DRAFT EXPRESS TERMS
FOR
PROPOSED BUILDING STANDARDS
OF THE
DIVISION OF THE STATE ARCHITECT (DSA-AC)

REGARDING THE CALIFORNIA BUILDING CODE
CALIFORNIA CODE OF REGULATIONS, TITLE 24, PART 2

2013 CALIFORNIA BUILDING CODE
INTERVENING CODE CYCLE

11B-406 Curb ramps, blended transitions and islands

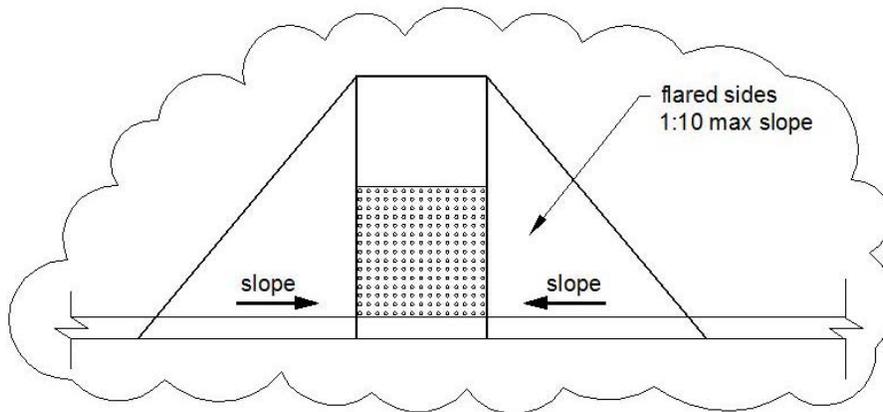
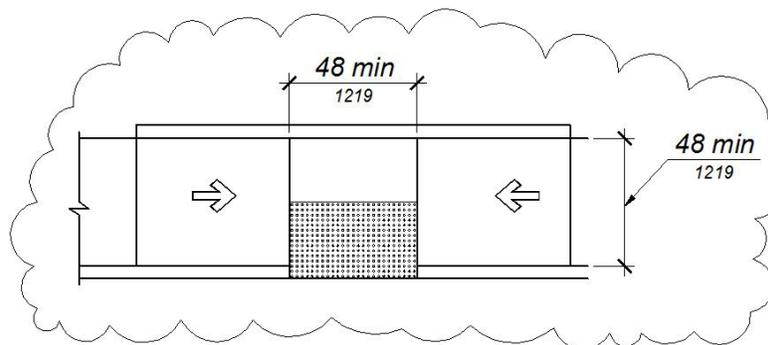
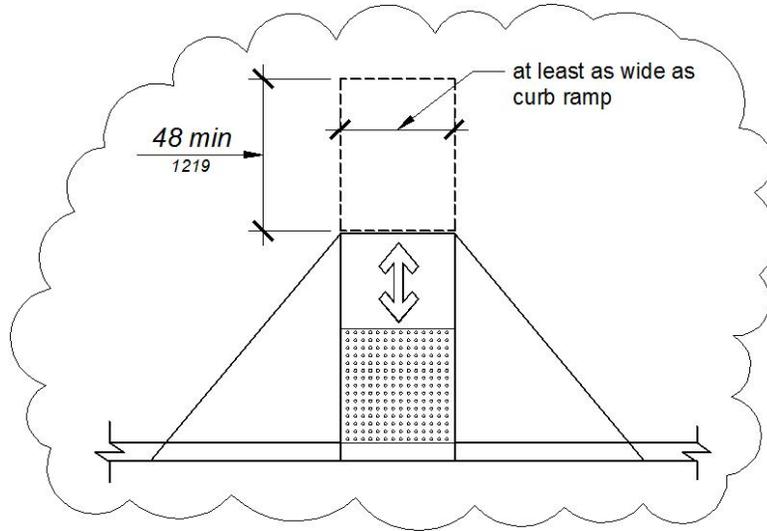
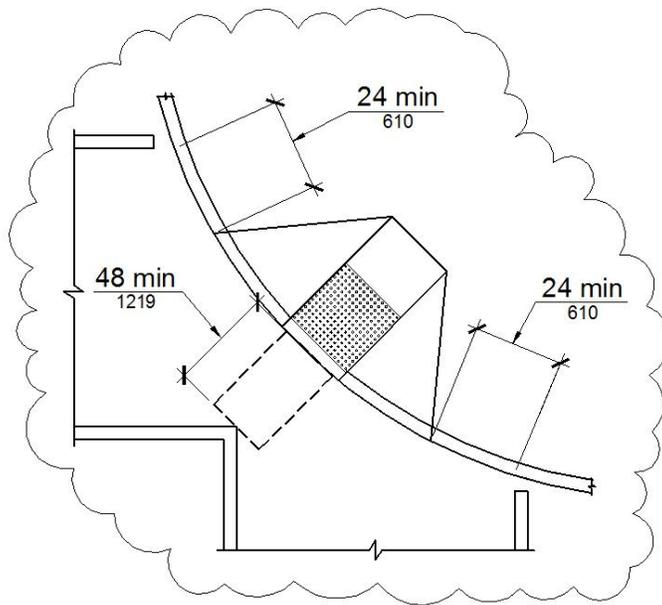
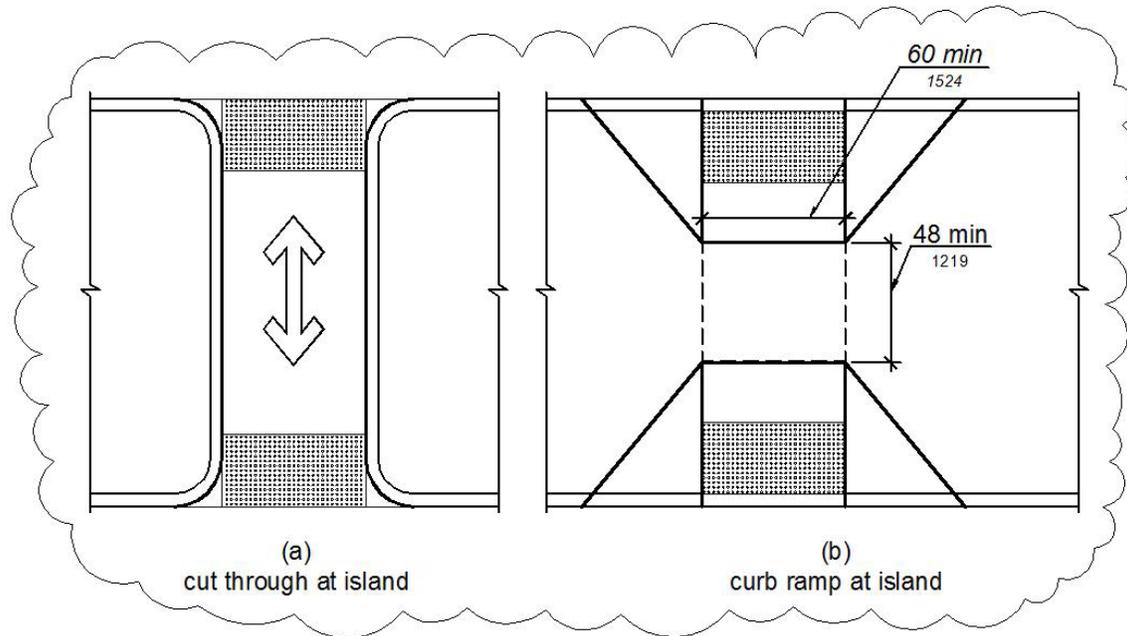
Figure 11B-406.5.7 11B-406.5.8
Counter Slope of Surfaces Adjacent to Curb Ramps

Figure 11B-407.2.2.2 Visible Hall Signals

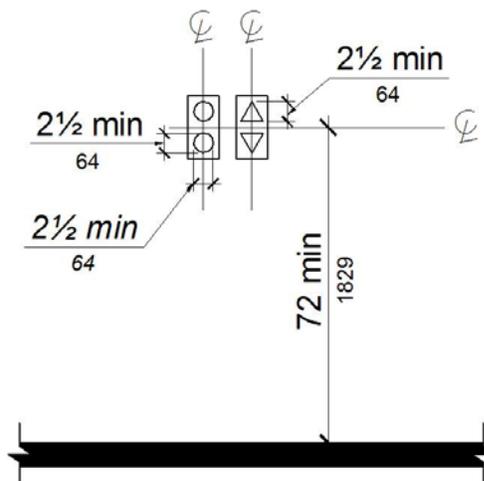
1. **Reserved.** ~~Destination-oriented elevators shall be permitted to have signals visible from the floor area adjacent to the hoistway entrance.~~
2. **Reserved.**

Figure 11B-407.2.3.2
Car Designations on Jamb of Destination-Oriented Elevator Hoistway Entrances

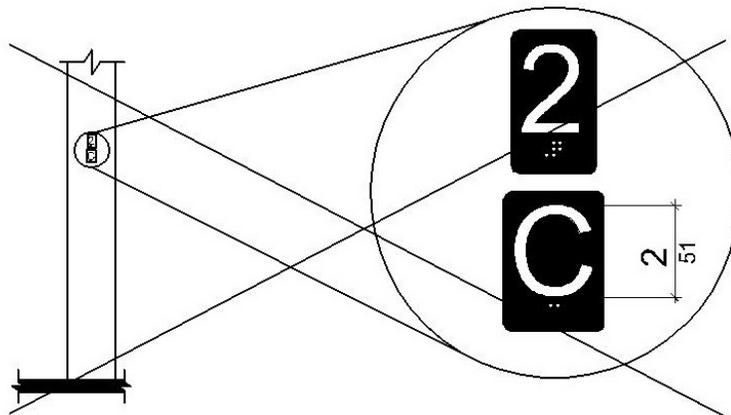
11B-407.2.3.2 Reserved. Car designations. Destination-oriented elevators shall provide tactile car identification complying with Sections 11B-703.2 and 11B-703.4.1 on both jambs of the hoistway immediately below the floor designation. Car designations shall be provided in both raised characters and Braille. Raised characters shall be 2 inches (51 mm) high. Raised characters shall be white on a black background. Braille complying with Section 11B-703.3 shall be placed below the corresponding raised characters. Applied plates are acceptable if they are permanently fixed to the jamb.

**Figure 11B-407.4.1
Elevator Car Dimensions**

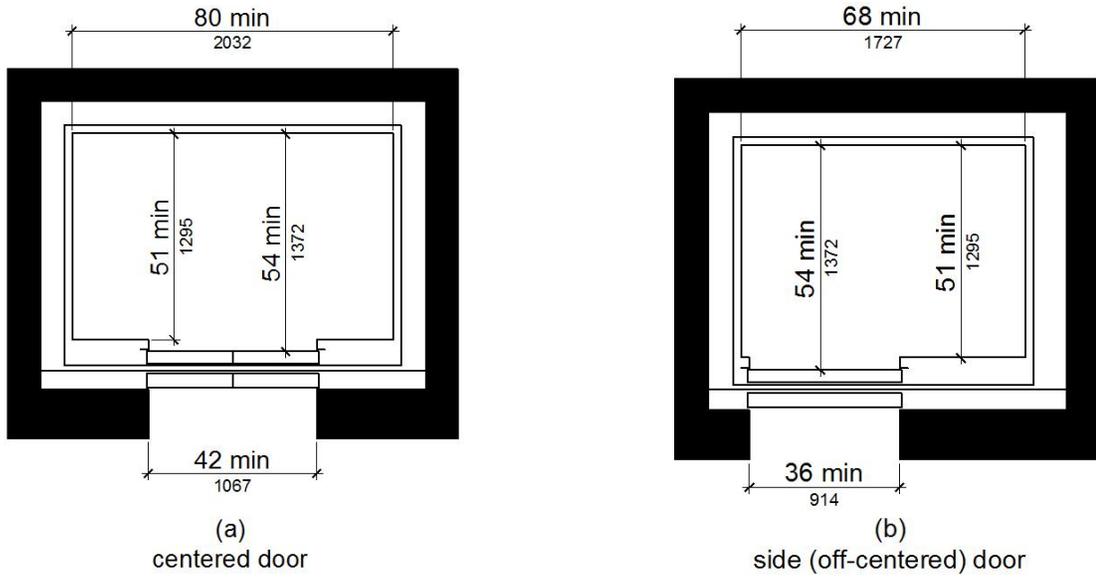
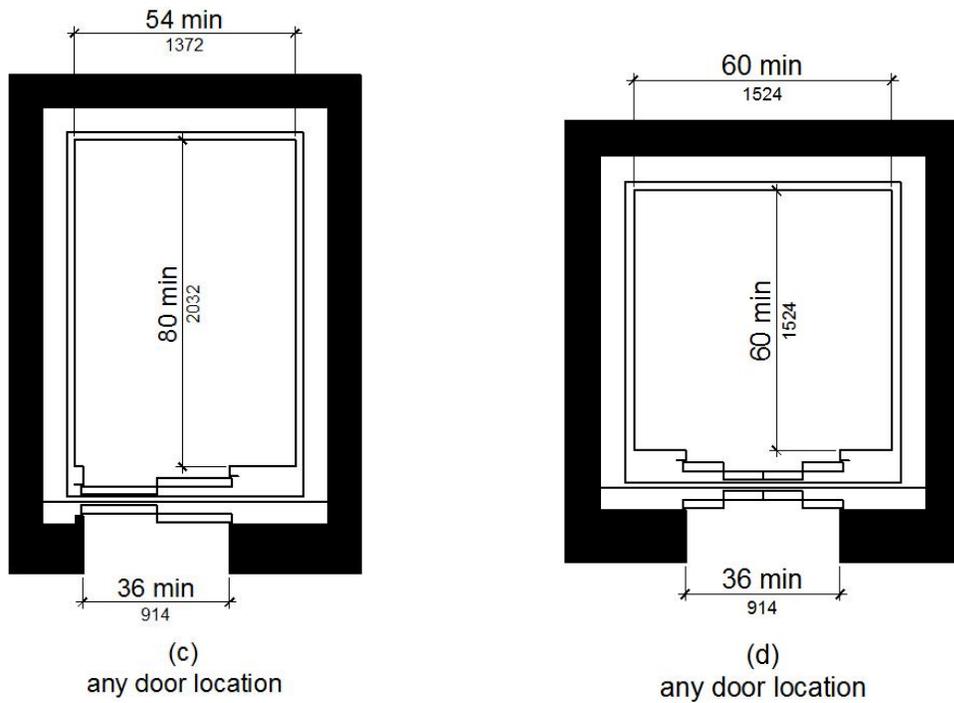
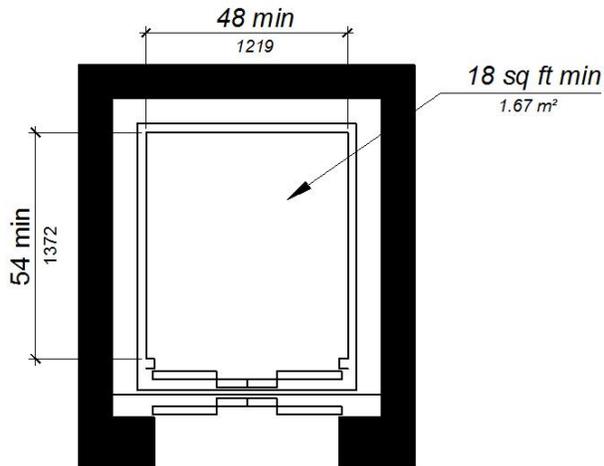
Exception: *In existing buildings, where existing shaft configuration or technical infeasibility prohibits strict compliance with Section 11B-407.4.1, existing elevator car configurations that provide a clear floor area of 18 square feet (1.67 m²) minimum and also provide an inside clear depth 54 inches (1372 mm) minimum and a clear width 48 inches (1219 mm) minimum shall be permitted.*

Figure 11B-703.8.5
Low Resolution VMS Signage Characters

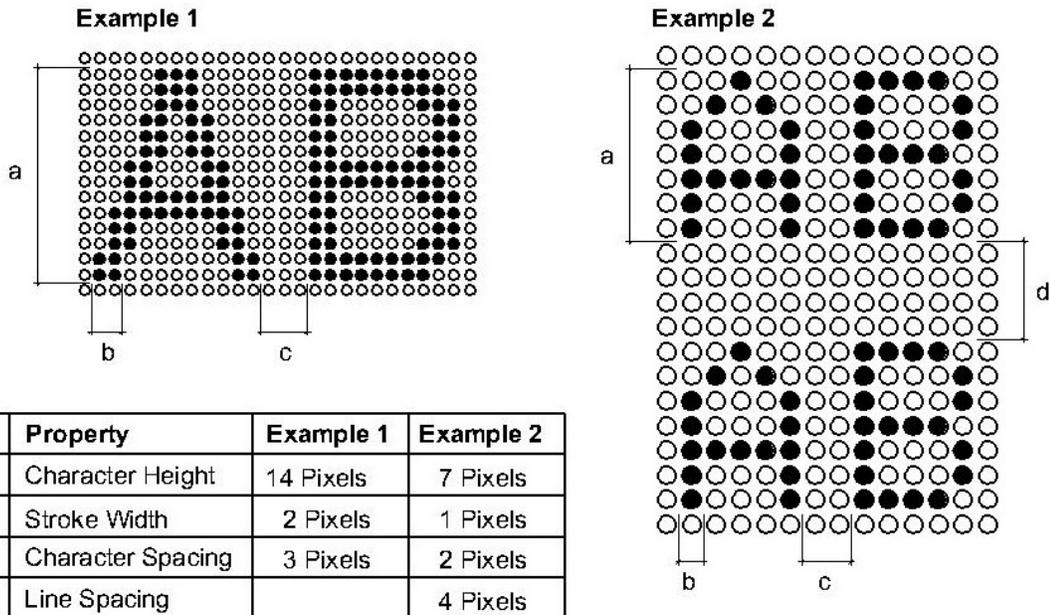
Table 11B-703.8.5 Pixel Count for Low Resolution VMS Signage

<u>Character Height</u>	<u>Character Width Range</u>	<u>Stroke Width Range</u>	<u>Character Spacing Range</u>
<u>7</u>	<u>5-6</u>	<u>1</u>	<u>2</u>
<u>8</u>	<u>6-7</u>	<u>1-2</u>	<u>2-3</u>
<u>9</u>	<u>6-8</u>	<u>1-2</u>	<u>2-3</u>
<u>10</u>	<u>7-9</u>	<u>2</u>	<u>2-4</u>
<u>11</u>	<u>8-10</u>	<u>2</u>	<u>2-4</u>
<u>12</u>	<u>8-11</u>	<u>2</u>	<u>3-4</u>
<u>13</u>	<u>9-12</u>	<u>2-3</u>	<u>3-5</u>
<u>14</u>	<u>10-13</u>	<u>2-3</u>	<u>3-5</u>
<u>15</u>	<u>11-14</u>	<u>2-3</u>	<u>3-5</u>
